ADDENDUM NO. 4

VALE FACILITY ADDITION/RENOVATIONS AND MAINTENANCE/IT FACILITY PROJECTS

This Addendum consists of pages ADD 4-1 and attached and attached Addendum No. 4 from Gibraltar Design dated September 29, 2025, consisting of 2 pages and 6 Drawings.

Addendum Four (AD.04) to the drawings and specifications prepared by Gibraltar Design for **Valparaiso Vale Facility Addition/Renovations and Maintenance/It Facility and Related Work** for Valparaiso Community Schools, Valparaiso, Indiana.

C-107

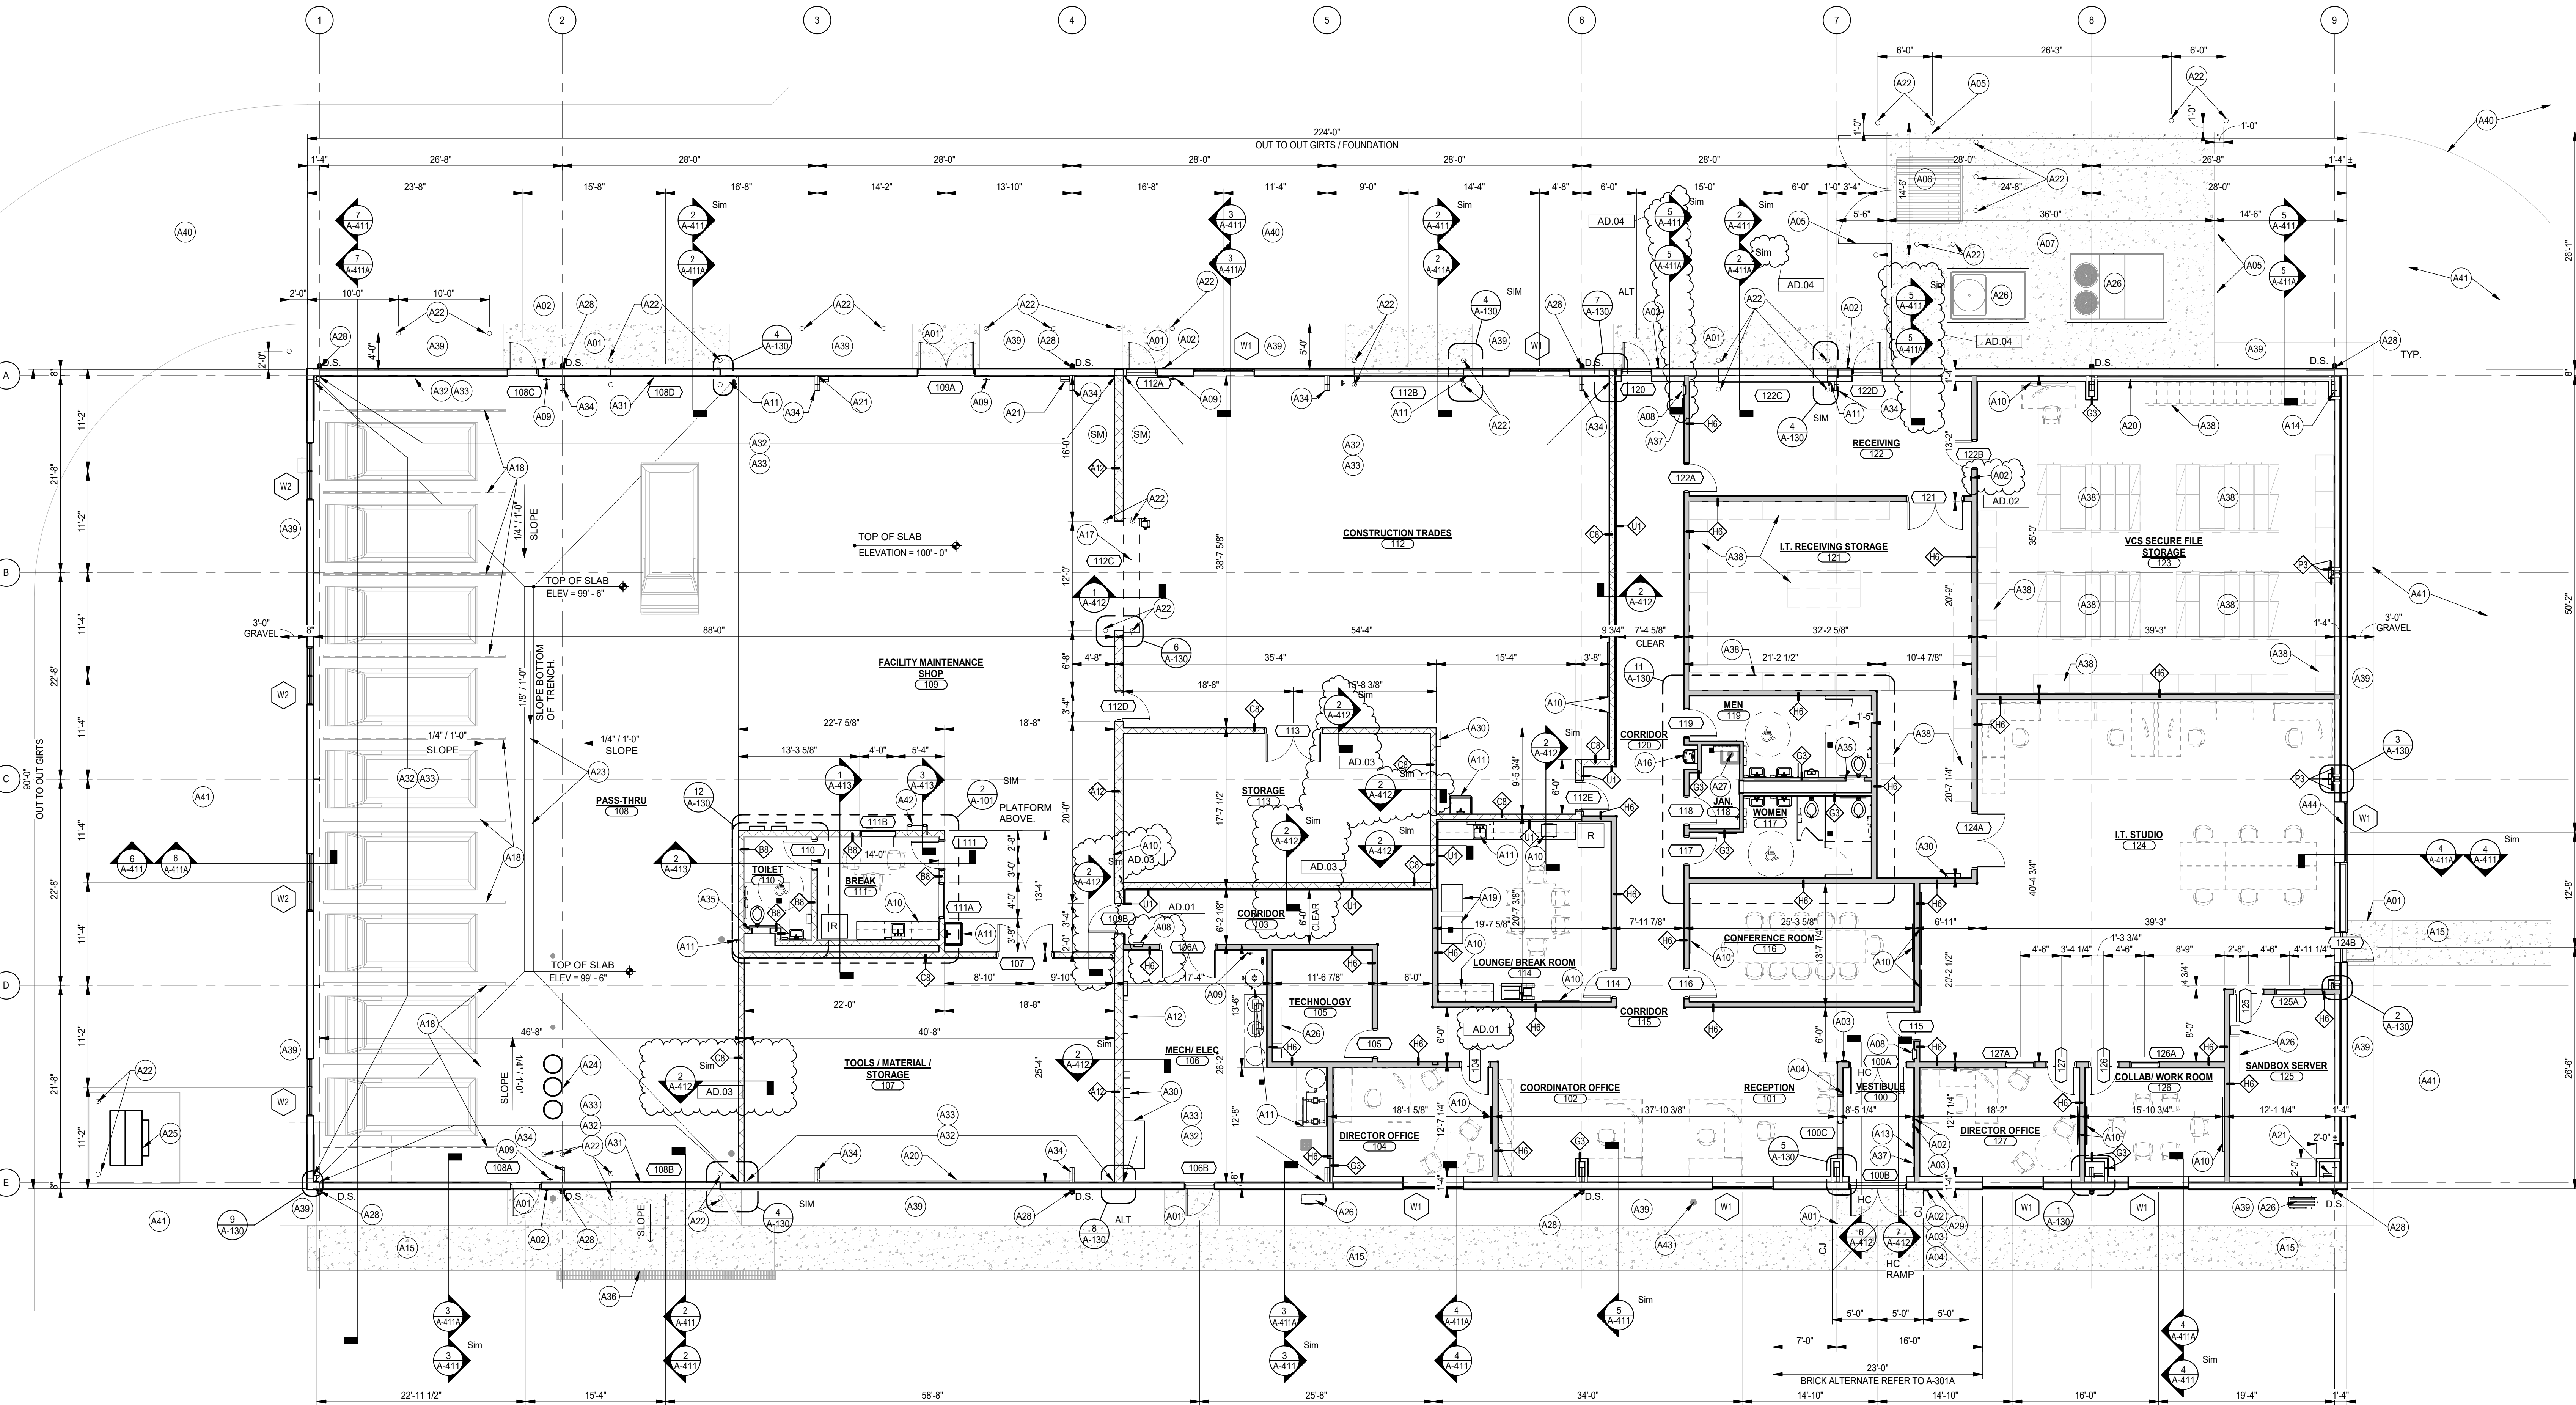
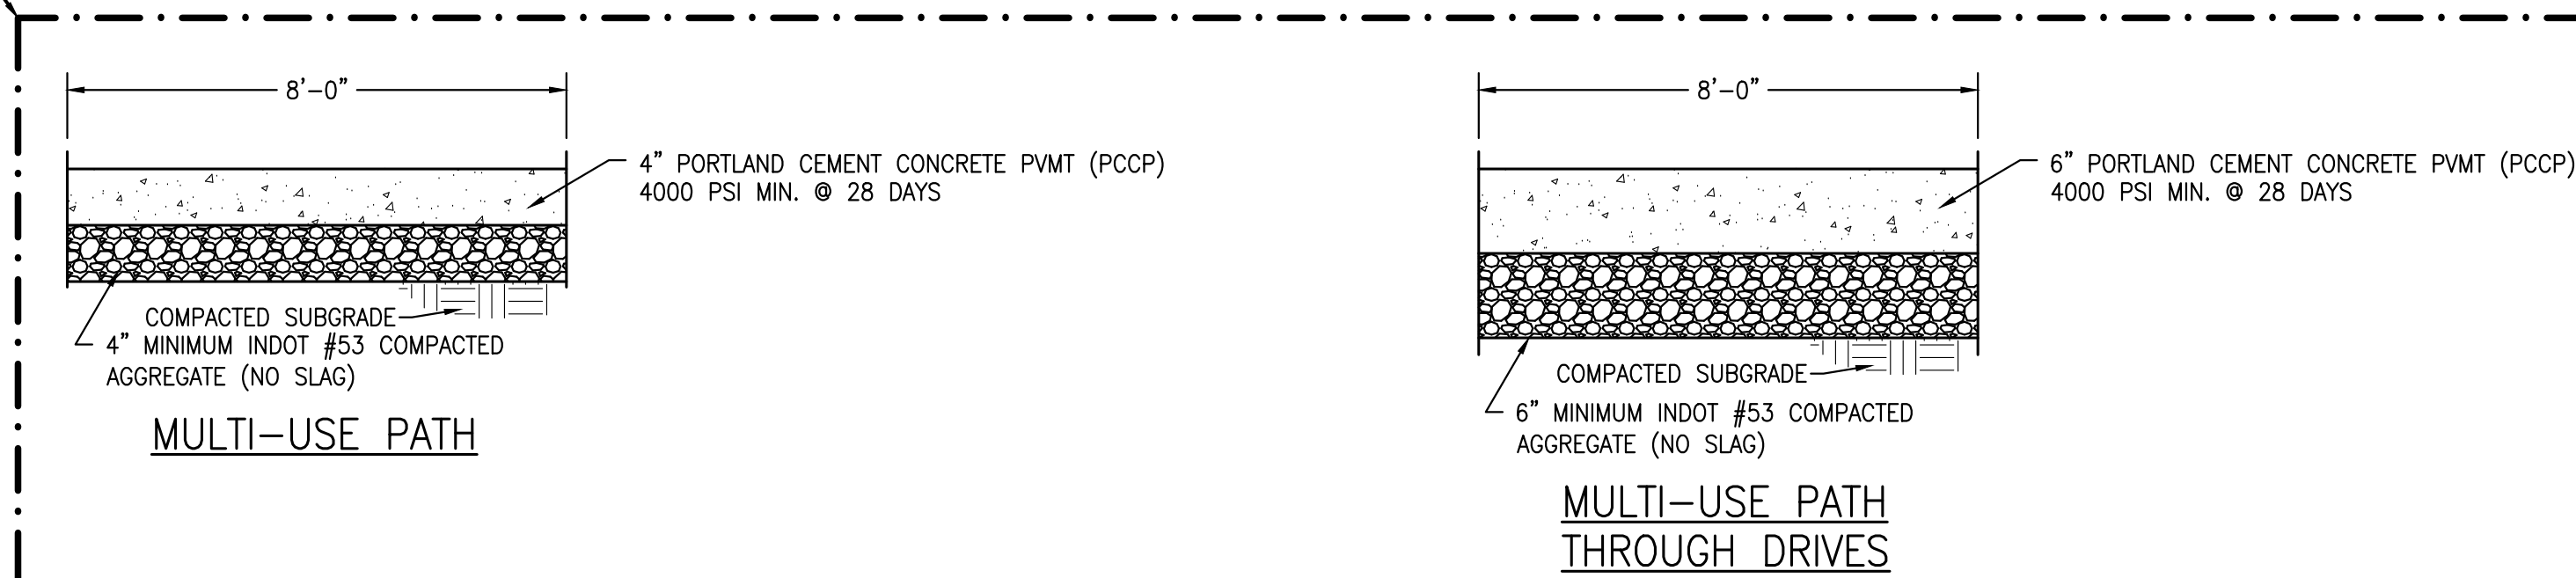
6. Sheet C-107

- A. Refer to revised, full-size drawing, included in this Addendum, for revisions below.
 - 1. Labeled the Multi-Use Path Detail and Multi-Use Path Through Drives Detail as an Alternate.

1. LABELED THE MULTI-USE PATH DETAIL AND MULTI-USE PATH THROUGH DRIVES DETAIL AS AN ALTERNATE.
